Access Compliance Report

Public Rights-of-Way

(Curb Ramps)

Intersection ID: 50272	Main Street: SOUTH_BV	Cross Street: WHITTON_ST	Location: SE
ADA ID: 6E34F8836E4D	Ramp Type: Perp	Initial Pass/Fail: Fail	Overall Compliance: No
		Severity Score: 12.5

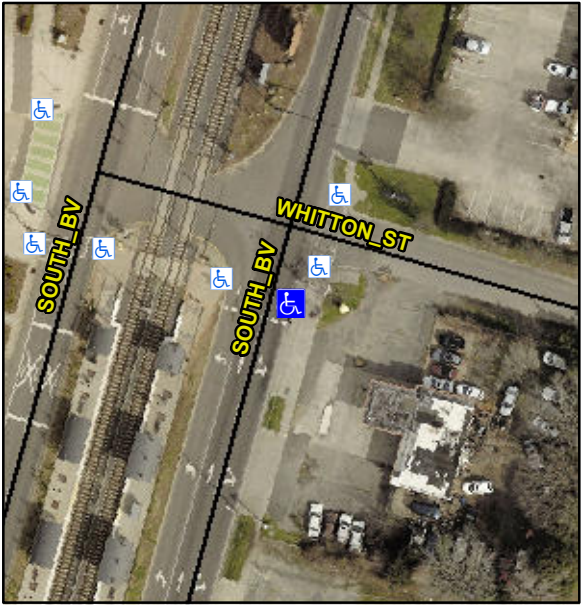
Codes/Mitigation Info/Possible Solution		Field Measurements/Component Compliance			
	Possible Solutions:				
	Remove & Replace Entire Ramp.				
	Surveyor Notes:				
	N/A				
	PROW/ADA:				
	Not Found, R304.5.3				
		Compliance	Description	Data	Compliance
		N/A	Ramp Length (in)	90.0	Yes
		Yes	Ramp Width (in)	48.0	No
		N/A	Flare Type LT	N/A	N/A
		N/A	Flare Slope LT (%)	N/A	N/A
		N/A	Flare Traversable LT?	N/A	N/A
		N/A	Landing Length (in)	N/A	N/A
		N/A	Landing Width (in)	N/A	N/A
		N/A	Landing Slope (%)	N/A	N/A
		N/A	Landing X Slope (%)	N/A	N/A
		N/A	Landing Curb? (Y/N)	N/A	N/A
		N/A	Shared Landing?	N/A	
		N/A	Gutter Ponding?	N/A	N/A
		N/A	Gutter Lip Ht (in)	N/A	N/A
		N/A	Painted X Walk1?	Yes	N/A
			X Walk 1 Direction	To NW	
		N/A	X Walk 1 Width (in)	118.0	N/A
			X Walk 1 Slope (%)	1.4	
			X Walk 1 X Slope (%)	0.7	
		N/A	Ramp inside XWalk1?	Yes	N/A
			Road Slope (%)	N/A	N/A
			Road X Slope (%)	N/A	N/A
		N/A	Any Obstructions?	N/A	N/A

Obstruction Type		
				N/A	N/A
				Yes	Surface Condition? (G/P)
					Good
Street 1 Name	SOUTH BV				
Stop Condition-Street 2	Signal				
Street 2 Name	N/A				
Stop Condition-Street 1	N/A				
Total Cost:	\$	1850.00
